**WESU / Wesleyan University
Spectrum Study – Amendment to
Directional Antenna Pattern
January 5, 2008**

Purpose

WESU filed an application (20070906AAD) to improve their broadcast facility from 1500 watts ERP (omni-directional) to 6000 watts ERP (directional) at the same height 10m HAAT (44m AGL).

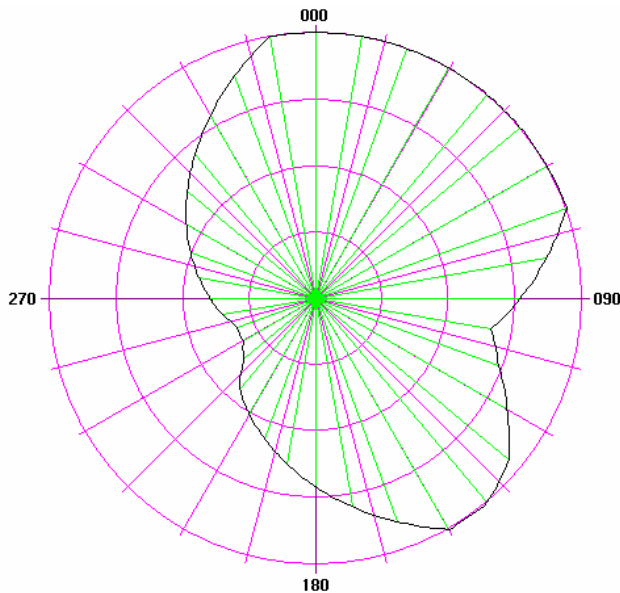
Upon later internal analysis, it was determined that the directional antenna pattern would need minor revisions to meet the conditions of 47 CFR 73.510(a). This Study reflects those revisions

The new analysis, using 54dBu interfering contours for WESU's existing and proposed/new facilities AND a new pattern, still demonstrates that the new facility will result in a net reduction of population receiving interference to surrounding TV6 facilities.

Degree	Field	Degree	Field	Degree	Field	Degree	Field
0	1.000	100	0.667	200	0.562	300	0.562
10	1.000	110	0.729	210	0.501	310	0.630
20	1.000	120	0.829	220	0.446	320	0.707
30	1.000	130	0.944	230	0.354	330	0.794
40	1.000	140	1.000	240	0.316	340	0.891
50	1.000	150	1.000	250	0.316	350	1.000
60	1.000	160	1.000	260	0.354		
70	1.000	170	0.794	270	0.398		
80	0.876	180	0.707	280	0.446		
90	0.764	190	0.630	290	0.501
